3.6 EXTERNAL STAIR & CORE ROTATION

3.7 LEVEL 5

ADDITIONAL DESIGN IMPROVEMENTS

Figure 3.5.1_The external stair has been redesigned to extend to the first level of the library.

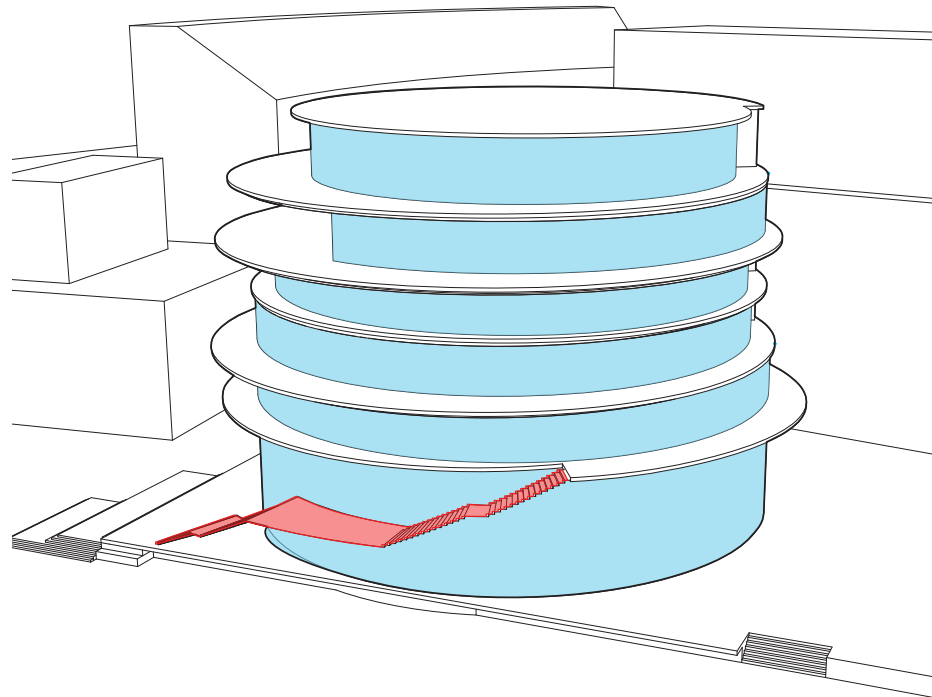
The external stair lodged within the Development Application extended to the mezzanine level only and was 3m wide at the base.

At the request of the City of Sydney (the library tenant), the external stair has been redesigned to extend to the first level of the library and widened slightly at the base to 3.2m wide. It has been carefully considered so as to not reduce the floor area of the Library.

This request was made to ensure a civic and public address is provided to the library with access previously via the lifts only. The flaring out of the stair at the base addresses The Boulevard, the primary pedestrian link to Darling Harbour and the foreshore.

Figure 3.5.3_The core is rotated 22.5 degrees from original position to the south

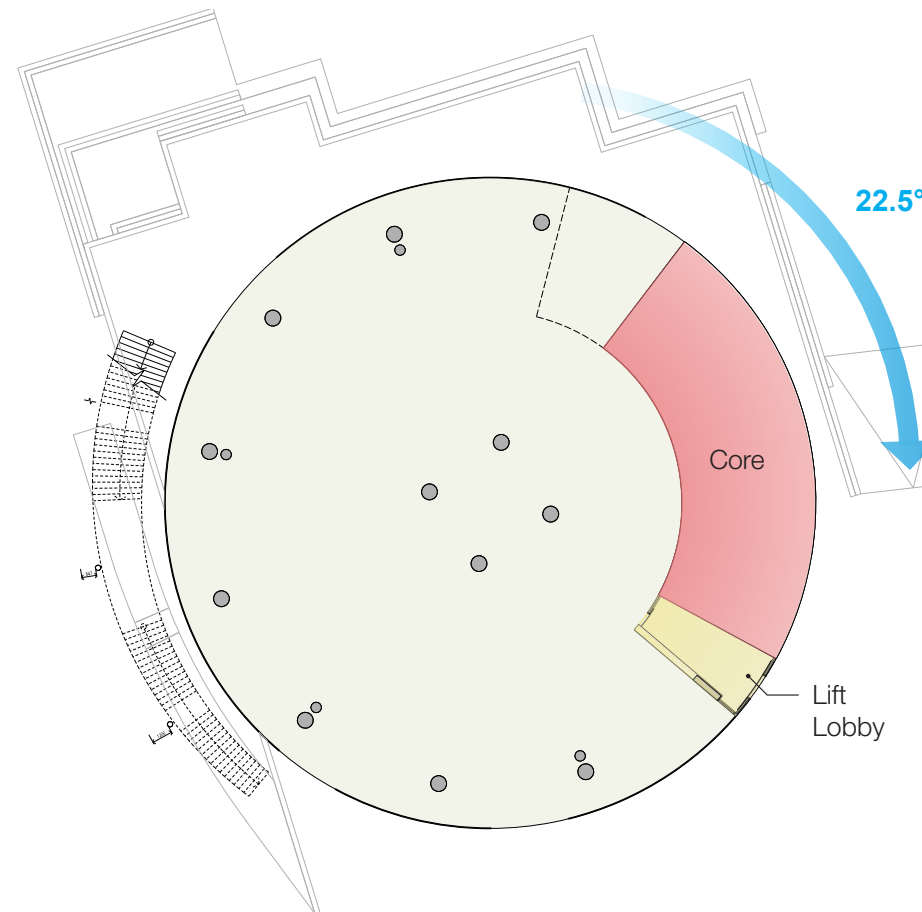
In discussions with the City of Sydney regarding a greater lobby presence facing The Square the location of the core has been adjusted.

The core has been rotated/pivoted 22.5 degrees in a clockwise direction to improve how the building is perceived from a number of key vantage points including:

1. Little Pier St/Factory Lane: A more active facade is now apparent from Little Pier St/Factory Lane. Refer to Figure 3.5.4 and 3.5.5.
2. The Square: A more prominent/visible lobby entry has been created from The Square. Refer to Figure 3.5.3.

Figure 4.5.2_Proposed Level 5 Bar/Restaurant

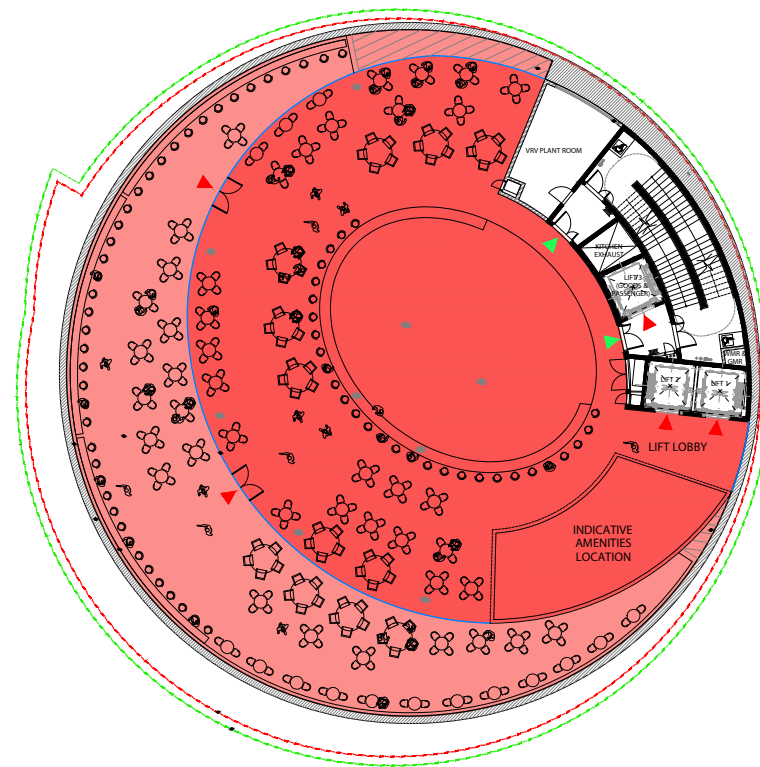
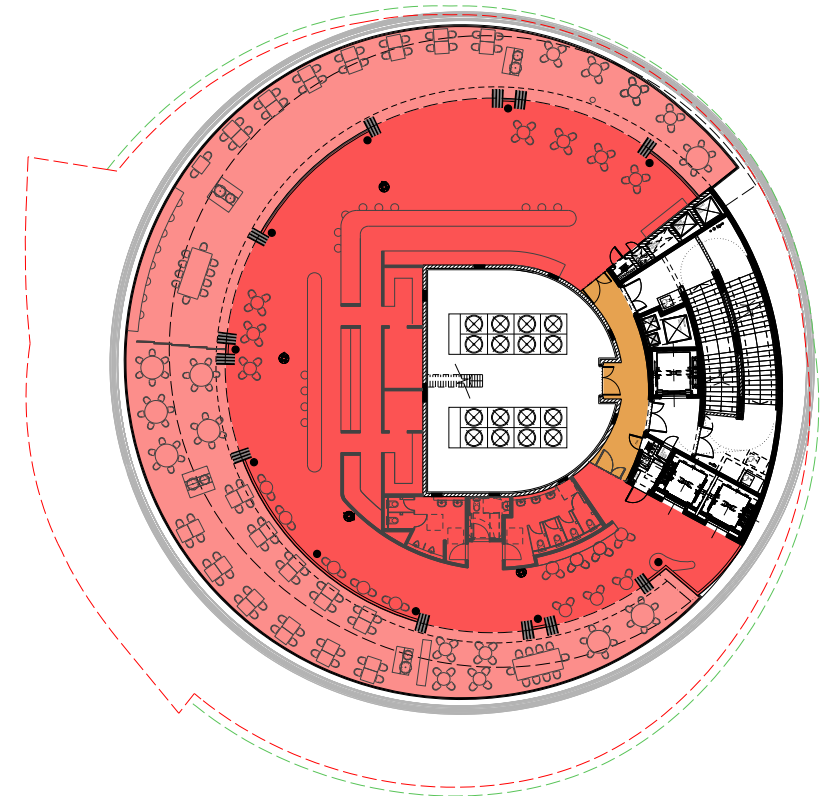
“..... The BCA Report lodged indicates the roof level restaurant and bar could be occupied by up to 689 patrons and the child care centre, with 90 spaces, would be operating until 7.00pm.”

It is noted that the proposal includes a rooftop restaurant and bar in addition to community facilities and markets. This appears to be inconsistent with the original purpose of the building on the North Plot and inappropriate to the location given

A reconsideration of the patron numbers for Level 5 has been undertaken having regard to:

- Centralised plant relocation to Level 5.
- Lifting rearrangements.

Level 5 has been replanned to accommodate a revised mechanical servicing strategy. The DA lodged provided mechanical plant rooms at each level of the building with louvres to the façade. A more efficient strategy has since been developed which replaces the level by level plant with a single open air plant room. This plant room is centrally located on Level 5.

- Reduced patron numbers of Level 5.
- Reducing the extent of louvres to the façade and therefore improving the façade of the building.
- A more sustainable design outcome assisting with Green Star targets.
- A better operational system for tenants.
- Improved lifting waiting times.

Figure 4.2.1_Proposed Ground Floor Plan - Market Hall Tenancy Layout

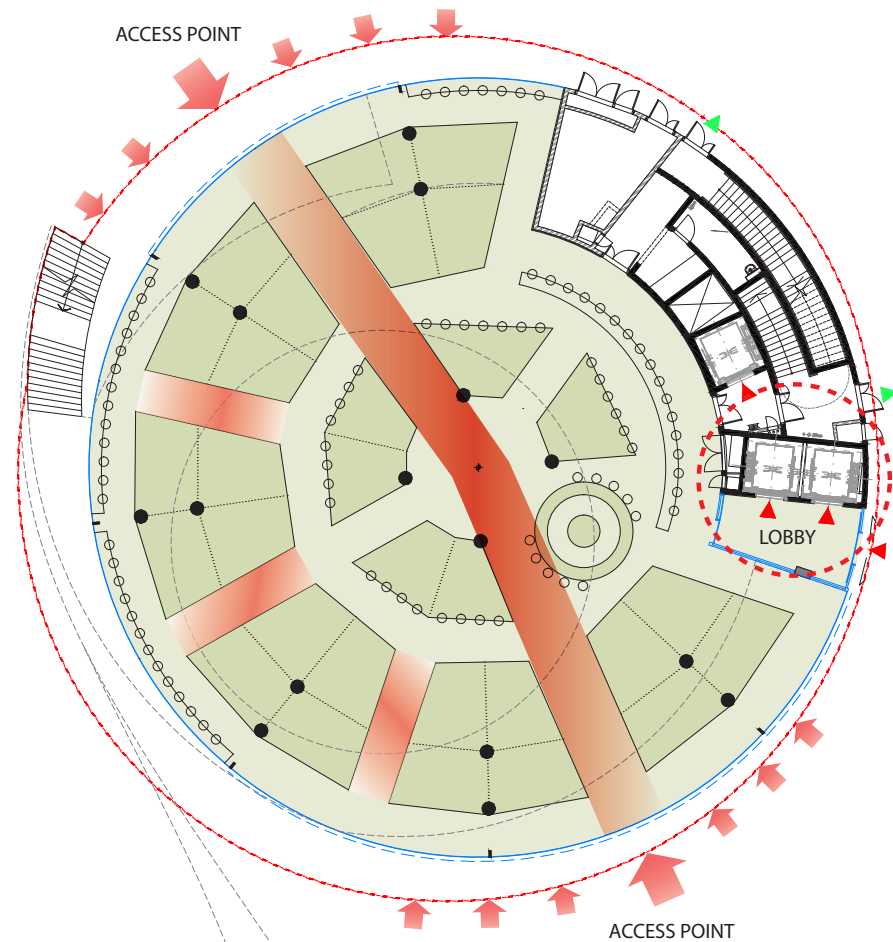
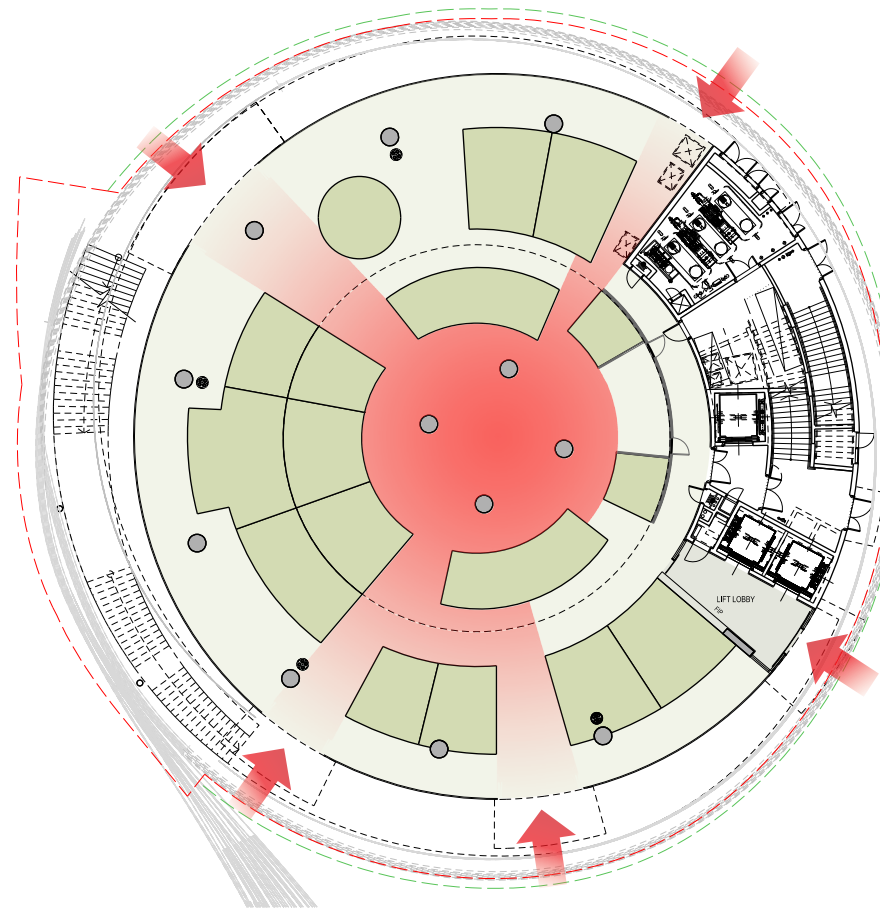
The layout of the market hall has developed since the DA that was submitted in March 2016. There has been a reduction of the number of tenancies from 32 tenancies to 18 tenancies to respond to loading and traffic requirements. The access spine has been maintained from the north to the south and has shifted with the rotation of the core.

The main entry to the north has shifted to align with the landing of the external stair and public domain terraces. As a result of the benefit of rotating the core a secondary entry has been created to the north west to capture people walking from Little Pier St.

To the south an entry has been created at the top of the public domain ramp to capture people at this node which reinforces pedestrian connectivity.

Figure 4.3.2_Indicative Ground Floor Facade Types

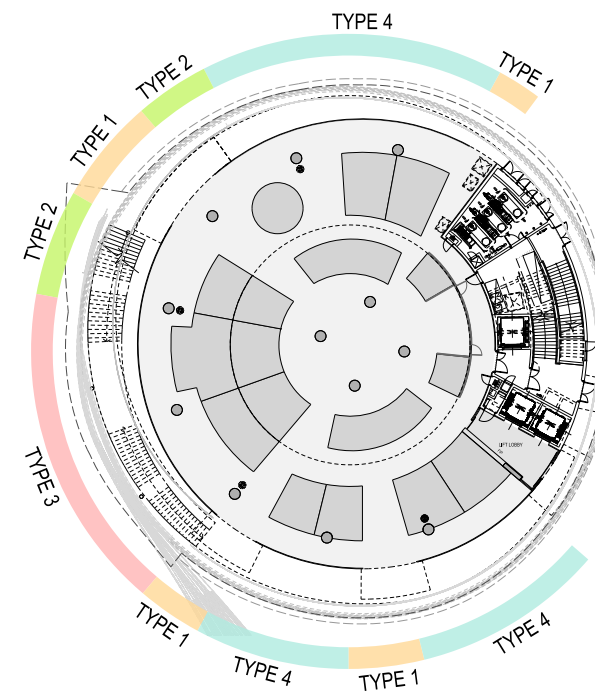
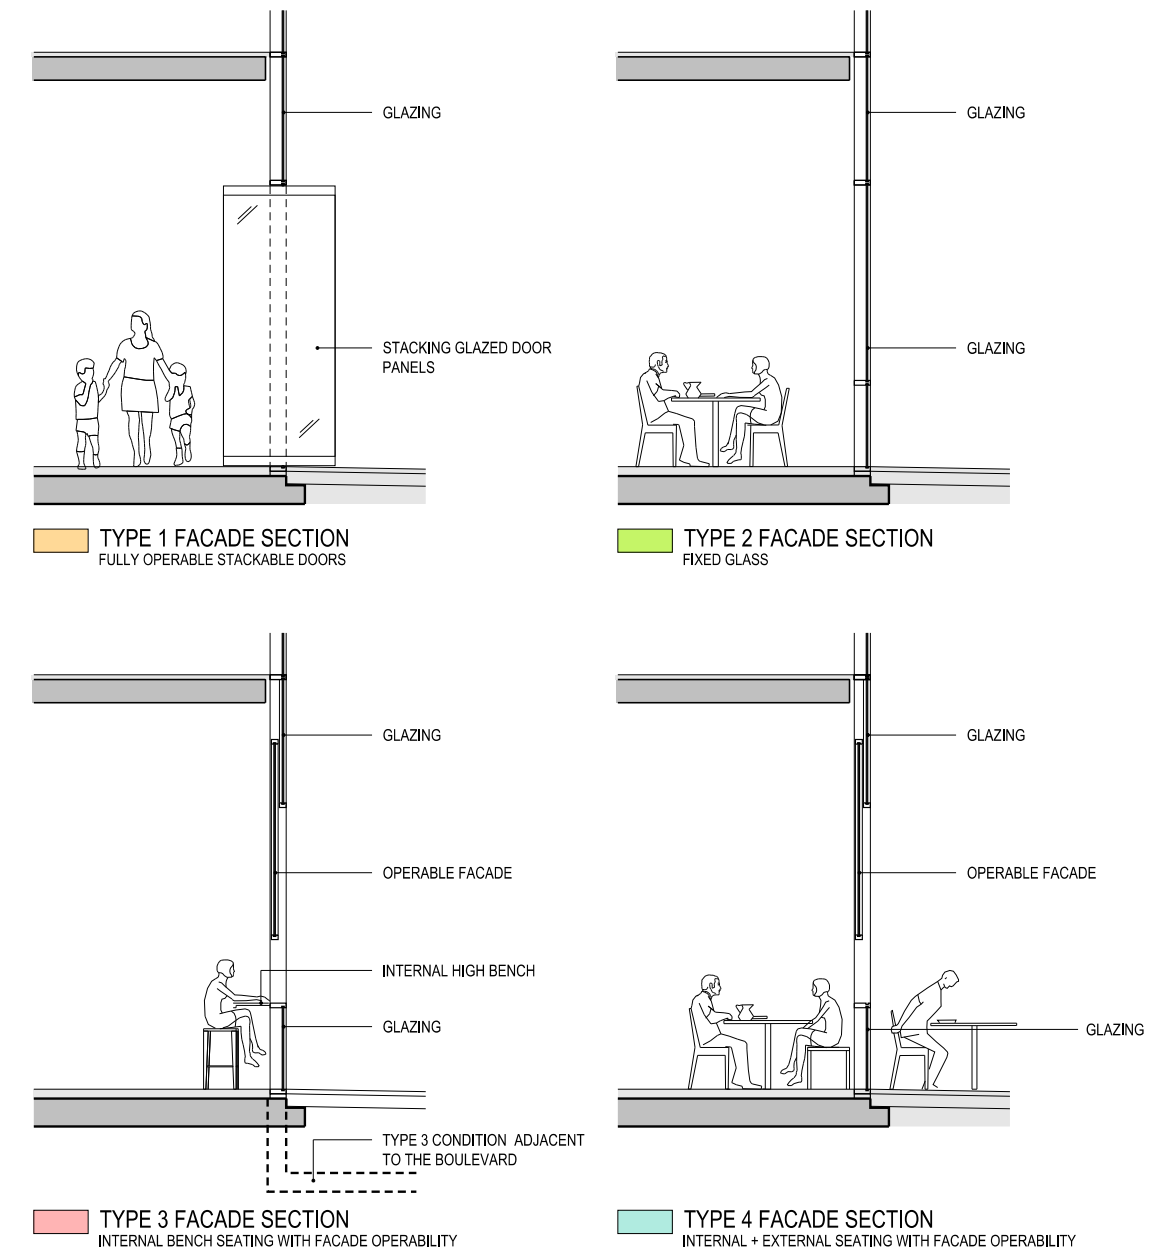
Facade operability options have been developed since the DA was lodged in March 2016. Four facade typologies have been included within the RTS to provide further detail in respect to operability options across the facade.

The exact extent of each facade type will be confirmed in detail with future tenants and/or market operators and any deviation to the design submitted within the RTS will seek approval from the Secretary General prior to the construction certificate.

Figure 4.4.2_Proposed Mezzanine

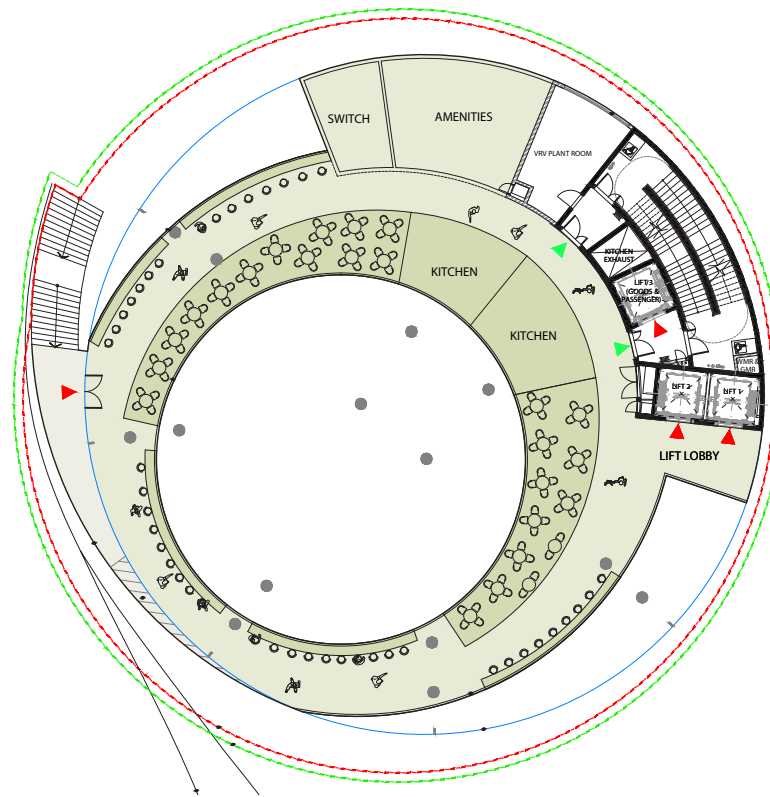
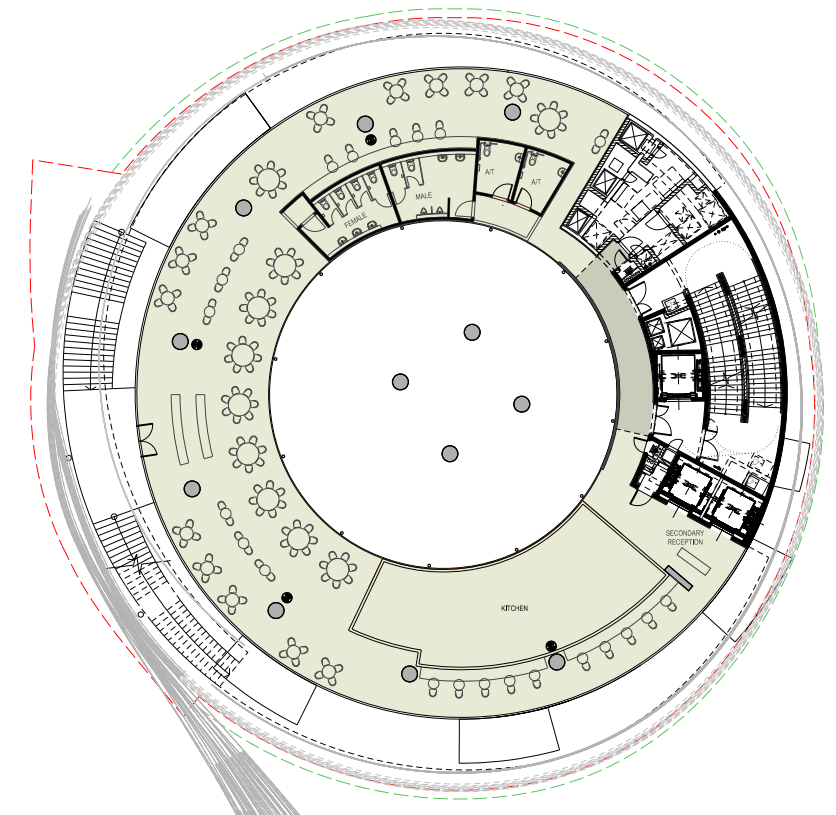
Since the lodgment of the DA, the Mezzanine level has been replanned to improve the functional layout to the food and beverage offering. The three separate voids have been consolidated into one central atria which not only enhances the Mezzanine design but also improves the relationship to the Ground Floor Market Hall.
